**RESPONSE TO COUNCIL ASSESSMENT REPORT FOR DA 2012/169  
473 & 483 LIVERPOL ROAD, STRATHFIELD SOUTH**

This letter has been prepared in response to Council's Assessment Report to the JRPP dated 3 April 2013, and is copied to the JRPP for their information and consideration.

**Figure 1 - Comparative South Elevation - red line showing outline/envelope of approved scheme**

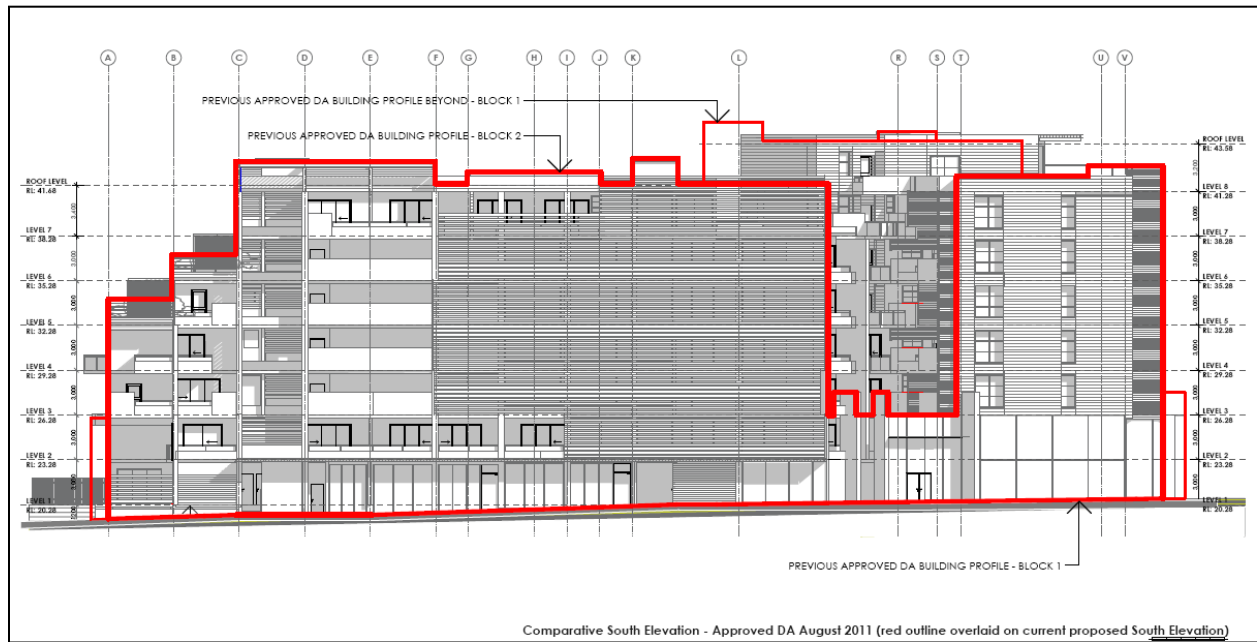
Council's report states that *"there are some clear protrusions from the approved envelope"* from prior DA 2011/032 (JRPP approval) and that this conflicts with our argument that the application generally retains the approved built form.

We do not suggest that there are no protrusions and indeed the proposal does involve a number of minor protrusions internally within the development, mainly where balconies have been provided to units. In terms of the general bulk and scale of the development, as can be seen in the comparative elevations below, the proposed scheme *does* retain the general envelope of the approved development. In considering potential impacts from the bulk and scale of the development, the purpose of the comparative elevations is to demonstrate that the development is substantially the same as the approved scheme and is appropriate in regard to its physical relationship and compatibility for the site and its surrounding locality.
